6 October 2021

**Submission to DART+ West Consultation No. 2, with a focus on Ashtown**

### Alternative pedestrian cycle bridge access routes

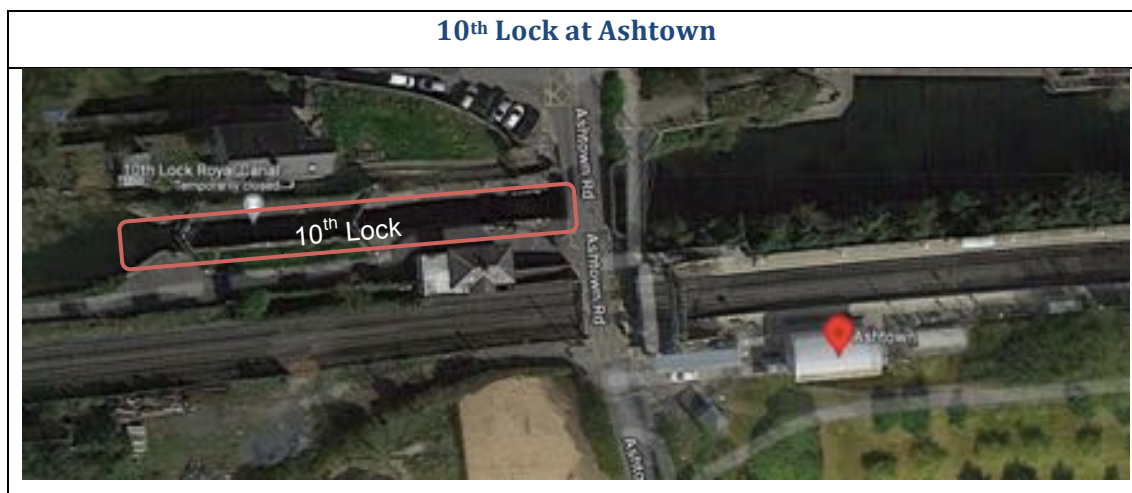
In addition, given it has the least impact in terms of connectivity and permeability in the community I believe that further exploration of option 9, where the railway is lowered under Ashtown road, is merited to examine its feasibility, environmental and heritage impacts and better understand the relative cost. While I have some reservations about its environmental impact I do believe it deserves further assessment.

The MCA which compared stage 1 options comments in relation to the construction costs for option 9 that “the cost and disruption of a scheme of this nature would be unsustainable and unjustifiable in comparison to other options available. It is proposed to discard this option without further consideration.” It could be interpreted, examining the commentary and ratings<sup>14</sup> given to other criteria for option 9, that much of the rest of the assessment was geared to reinforcing the rejection of option 9.

In particular, under biodiversity, it is stated that “During the construction stages water quality in the canal could be significantly impacted during the [d]ewatering required for the channelisation and realignment and lowering of the canal **in addition to the demolition of the canal bridge and locks**”. These impacts, in particular the demolition of the canal bridge and locks (it appears the 10<sup>th</sup> lock) seem very severe and it is difficult to understand why aspects such as this would be necessary (see picture below). While not ideal to disturb the canal, it would be good to have some evidence from previous construction projects where canal has been affected to understand the impact in more detail.

Current aerial map overlaid with 1888-1913 historic map (Source: Geohive)

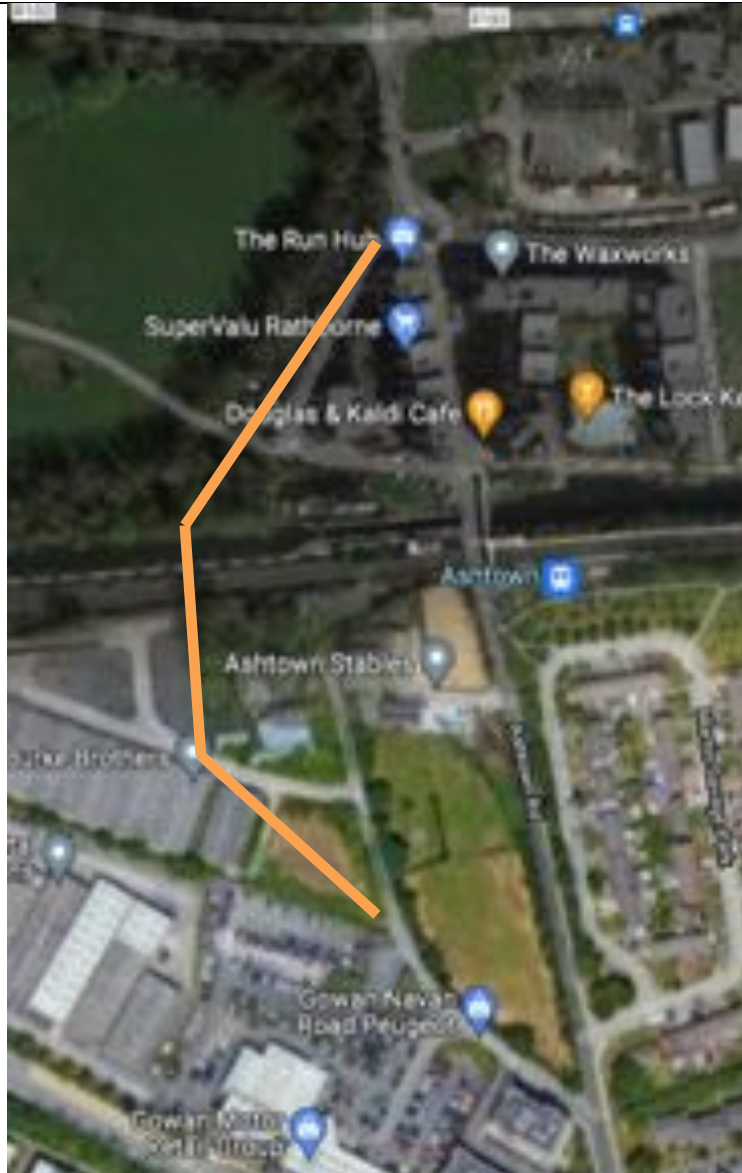
It is not clear that all the buildings within the boundary of the mill are old as some (on the east) appear to be relatively new. Where a detailed review has not already been conducted it would be worthwhile understanding exactly which parts of the site need to be protected given the significant impact on the stables as a result. Also, it is also an opportunity for Fingal CoCo to engage with the owner to better maintain the protected structure which has had numerous fires in the last two years. It would be very unfortunate if an existing business/leisure facility was significantly impacted by a decision to avoid the mill only to have it fall into ruin due to continued neglect. Please see the maps below with the area in the red circle of interest. It appears that the (cream) building perpendicular to the road may be relatively new, but it is not clear what is the age of the building alongside Mill lane.
